BOARD OF ZONING APPEAL

BZA Number: 177687

LOCATION OF PROPERTY: 40 Valentine St, Cambridge, MA

Propose rear 3rd story addition by raising the rear roof ridge to match front roof to allow head room in side within Rear setback and increase FAR.

PLOT PLAN  
LOCATED AT  
40 VALENTINE STREET  
CAMBRIDGE, MA  
PREPARED FOR & OWNED BY  
SHILEI ZHOU  
SCALE: 1"=10'  
02/02/2022

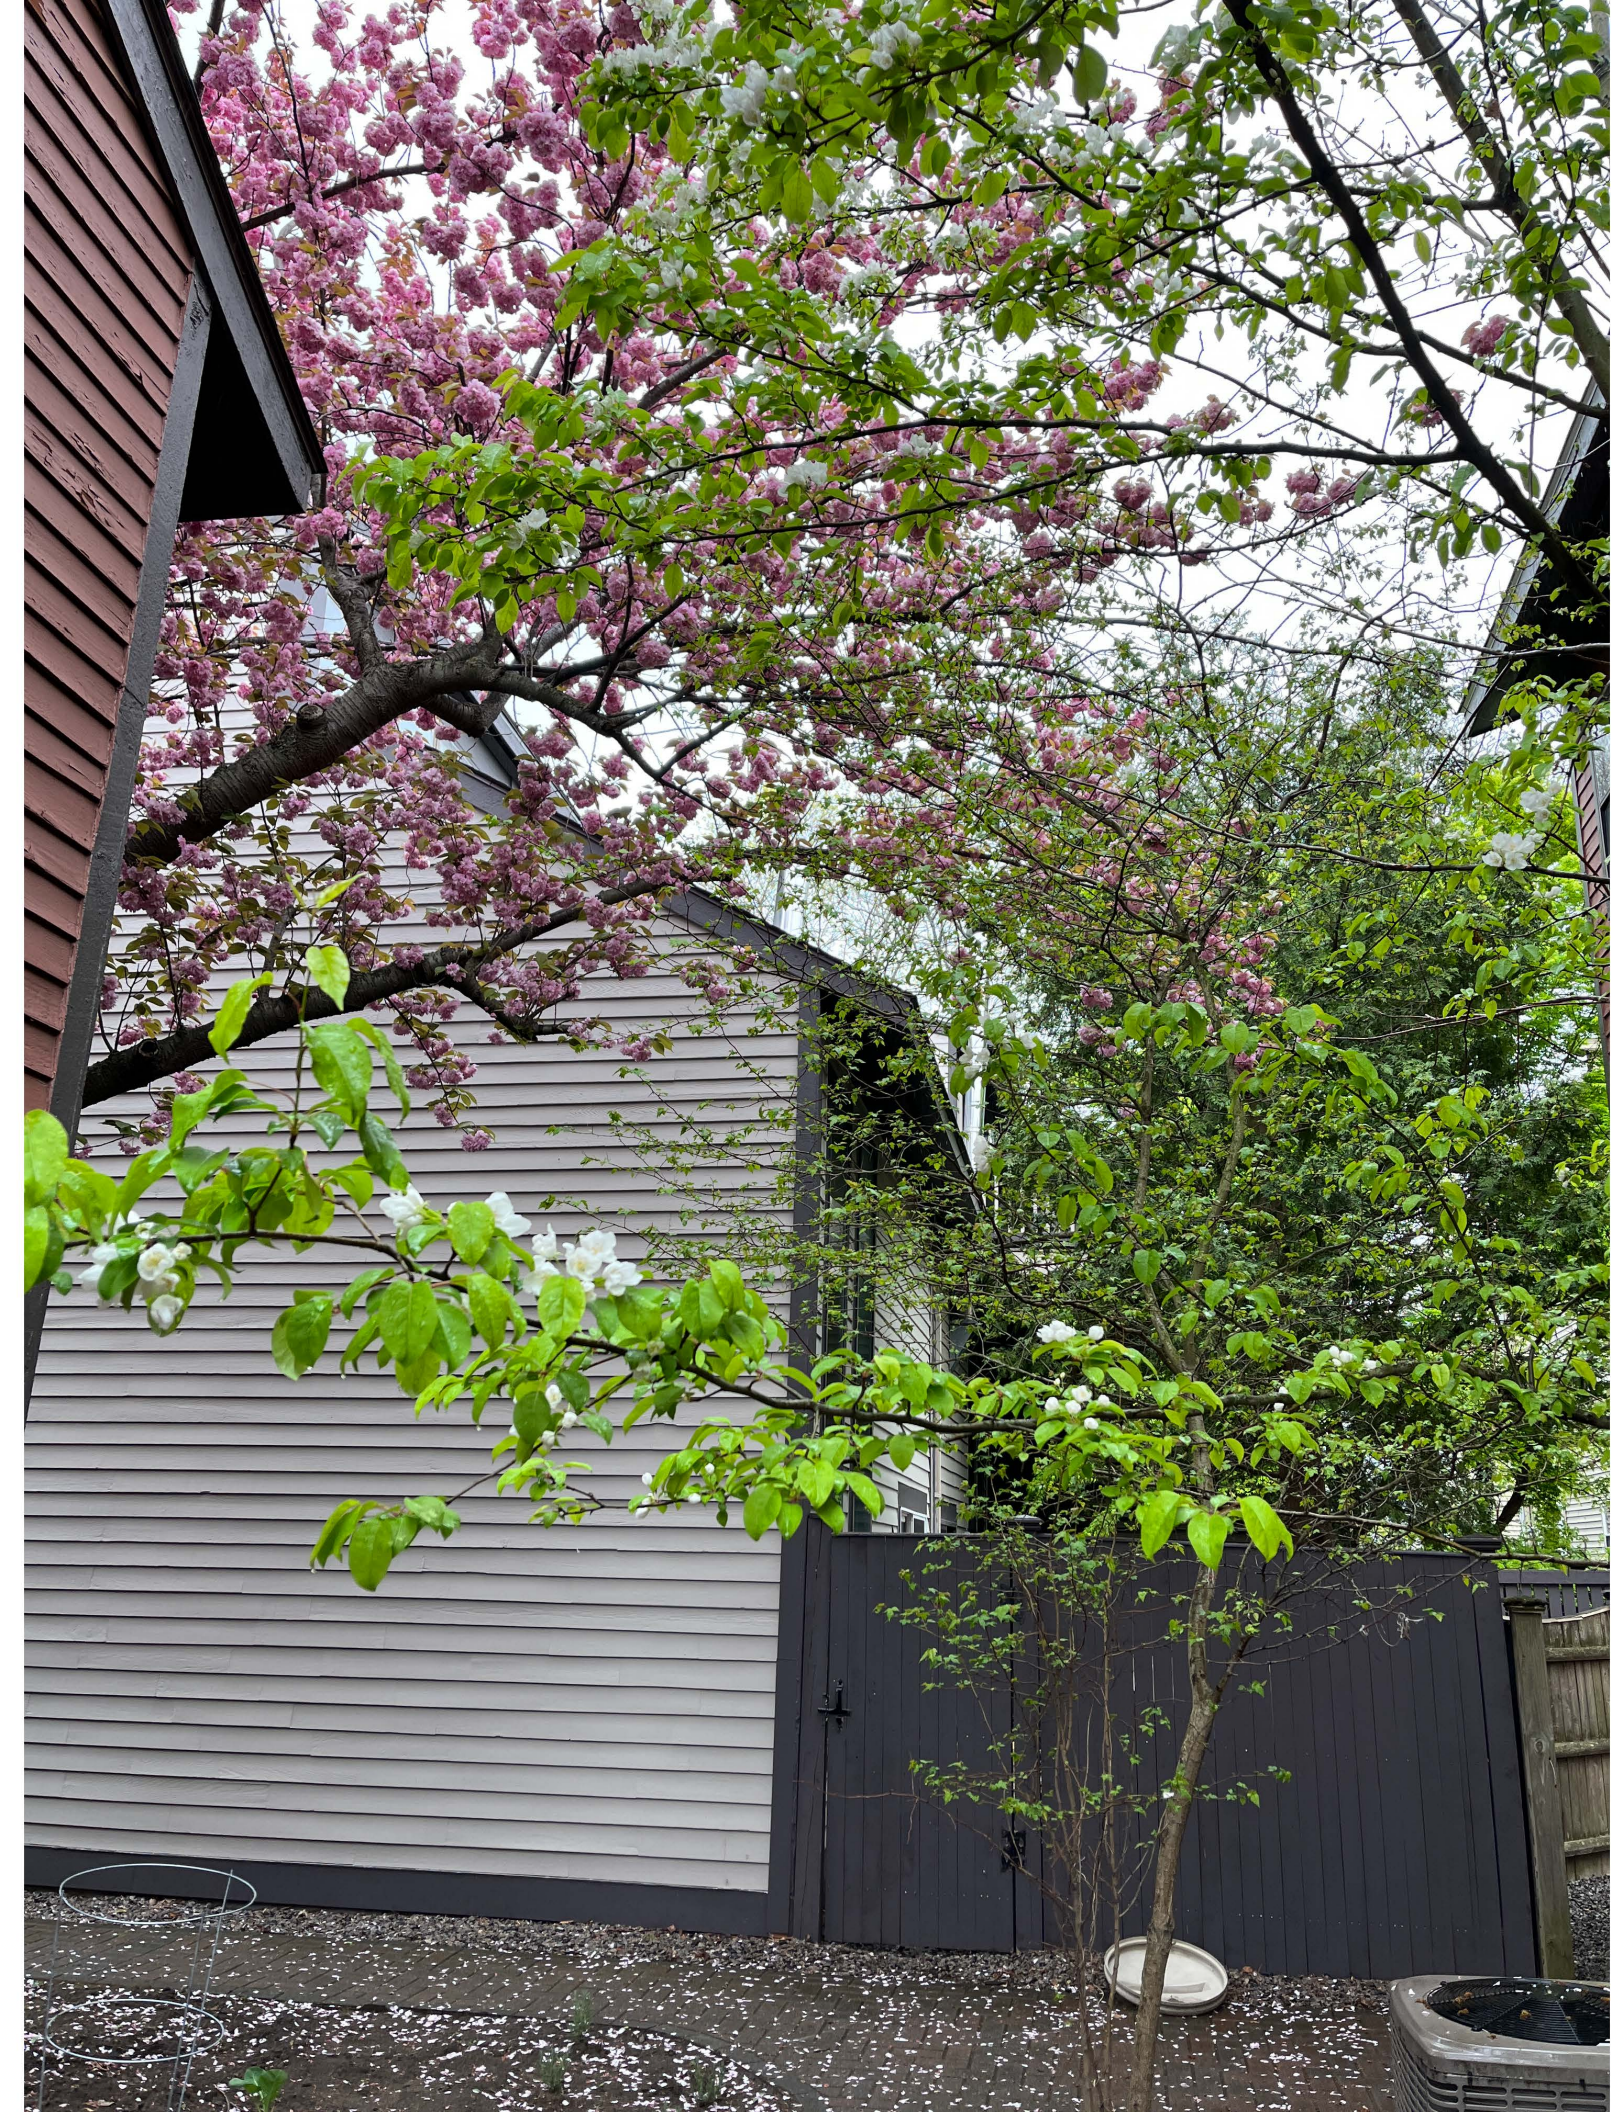
Furthermore, after multiple reviews of the application package, we are unable to ascertain how the applicant intends on increasing the rear set back from the current 10.8 feet, as indicated on the plot plan prepared by Alpha Omega Engineering dated 2/2/2022, to the 20 foot rear set back requested rear setback, as listed in the dimensional table contained within the application. Unless we are interpreting this incorrectly, which could very well be the case, we respectfully request clarification from the board or applicant on this item.

7           "Furthermore, after multiple reviews of the  
8 application package, we are unable to ascertain how the  
9 applicant intends on increasing the rear setback from the  
10 10.8 feet, as indicated on the plot plan to the 20-foot rear  
11 setback -- requested rear setback, as listed.

You are absolutely correct on the requested rear setback section. The number should not be changed and remains as 10.8', instead of 20'. A correction was made to reflect this. Also, the roof is not raised by 11'11". As compared to 38 Valentine st, we proposed the exact same approach and raise the rear roof ridge by 6' to match the front. It would create a mirror image as 38 Valentine. Therefore, a symmetrical building appearance.

# SITE IMPACT - Aerial

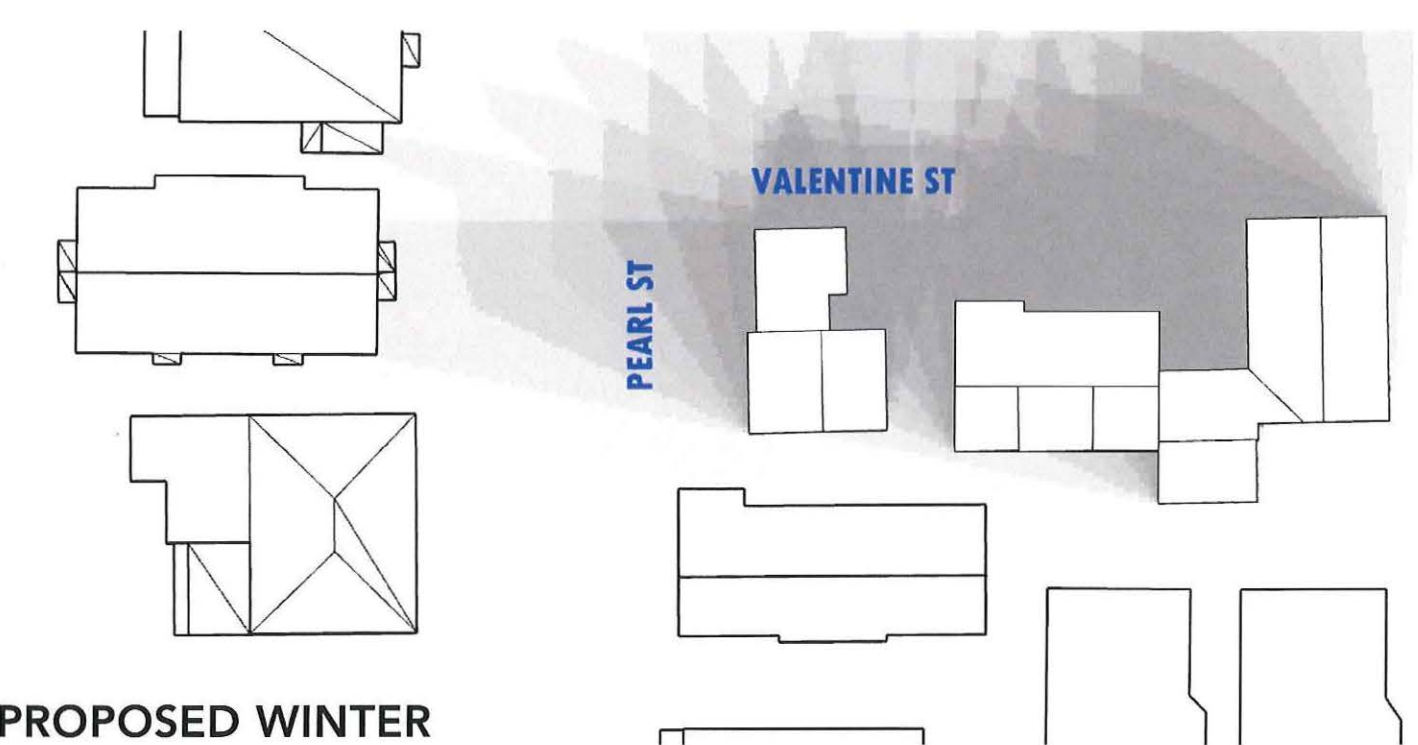
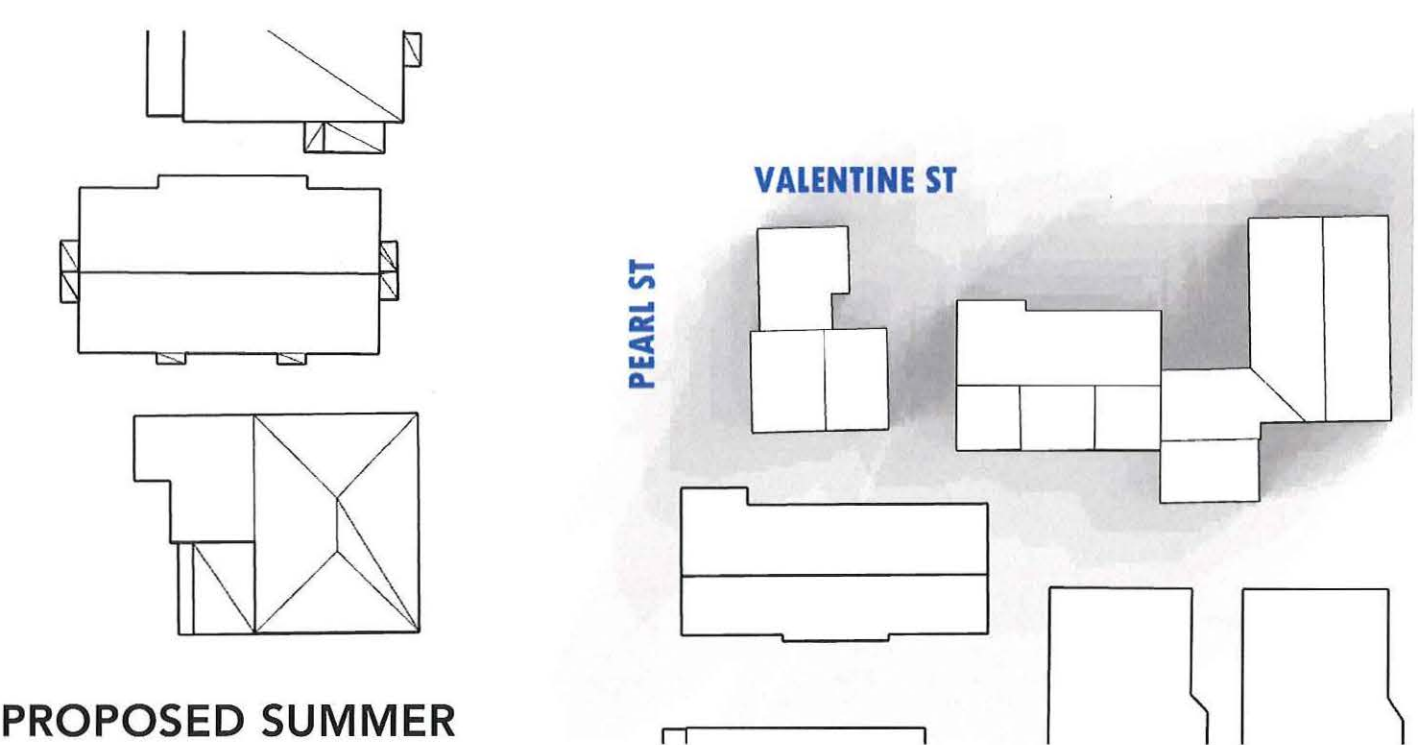
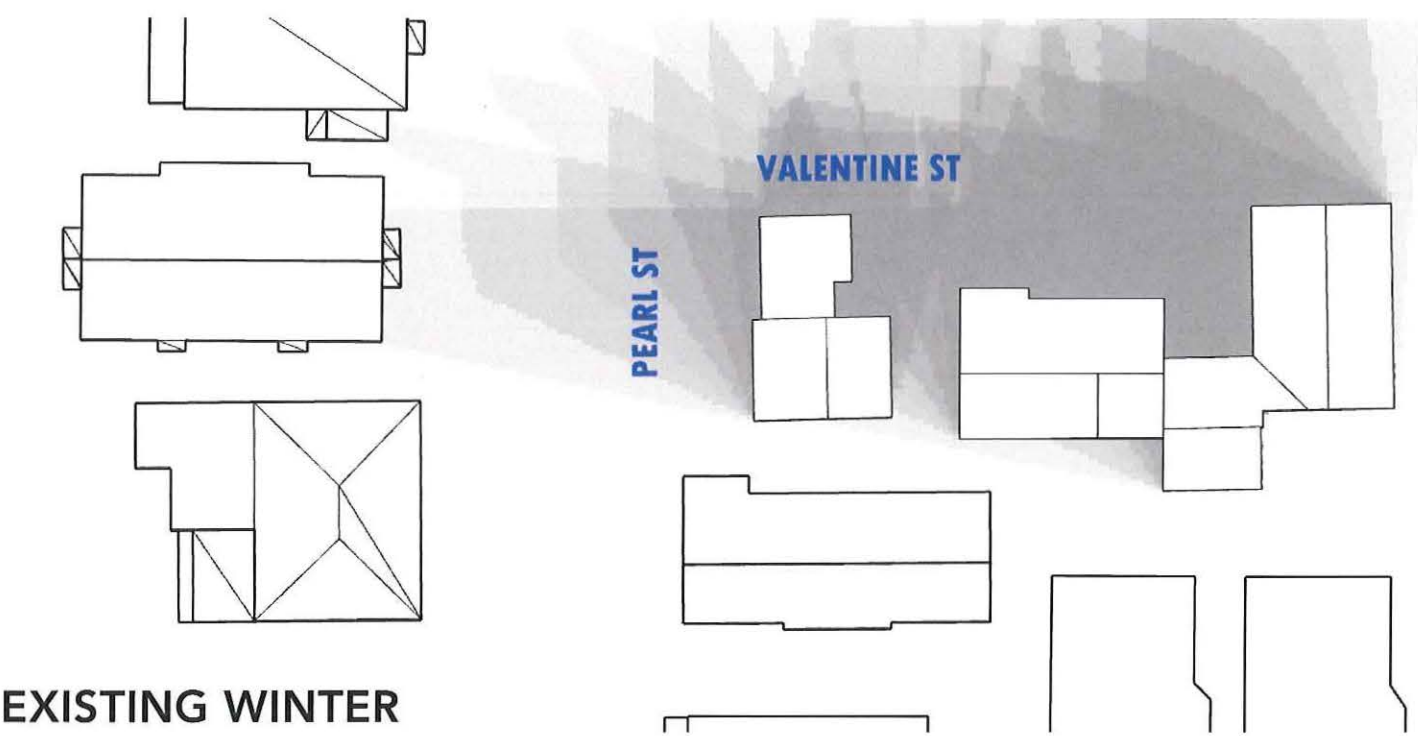
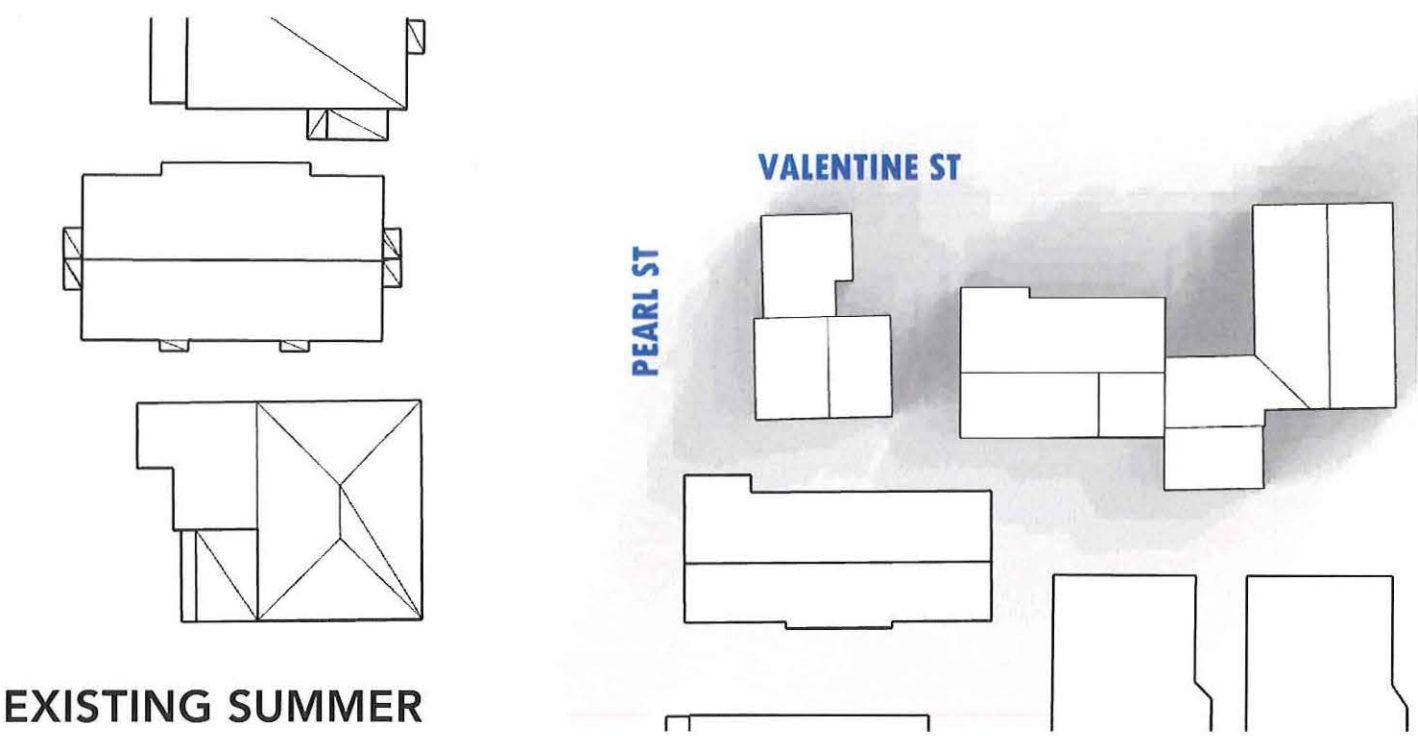
The petitioner states in their variance request that “ There will be no detriment to the public good as a result of the proposed roof raise. A similar variance has been previously granted to applicant's immediate abutter”. We strongly disagree with this statement and object to the comparison to a previous project that took place over a decade ago, as each project is unique and the effects of raising the rear roof peak 11’11” above the 3<sup>rd</sup> floor elevation to match the existing front roof peak will have significant detrimental impacts on neighbors, including our property. The additional building massing will create a cavernous effect to abutting properties while also blocking the already reduced available sunlight, essentially eliminating any natural sun light from entering the windows of abutting properties. The consequences of this 3<sup>rd</sup> floor addition are deeply disturbing. This change in roof line is a substantial design change and clearly diminishes the original architectural intent of designers Bell and Fandetti to utilize natural lighting. In addition, at a time when the City of Cambridge focuses on sustainable and local food production, the resulting reduction of available sunlight will have a measurable impact on our ongoing ability to grow produce on site. Also, as noted previously, we are obligated by deed to maintain and preserve, the mature flowering cherry tree located on our property and directly adjacent to this project, as depicted in one of the latter pages in the application package. This ornamental tree requires direct sunlight to thrive and would certainly be compromised as a result of the proposed project blocking the sunlight that it is accustomed to receiving. We take this responsibility as caretakers of this tree very seriously. It’s unclear to me if the applicant has performed any shading analysis or sun study related to the raised roofline’s impact on adjacent properties but I’d suggest that this would have been helpful in quantifying the proposed project’s impacts.

A shadow study is attached here. The "Aerial" view shows that the proposed work would not impact the open space given the current condition. The "East Facade" view focuses on the impact to your unit. The shadow pattern is not changed over your existing windows on the east side facing my unit. Also, I believe there are two skylights for your unit and the study shows there is no impact for them. One note, I think the pine tree in my backyard overgrows and extends over 20'+. It has a huge impact to both block sunlight to your unit and a danger to 42 Valentine in the event of storms. I have mitigated the risk by trimming down 7' to the same height as the front roof ridge as 42 Valentine. The tree can be further trimmed to clean the path for sunlight.
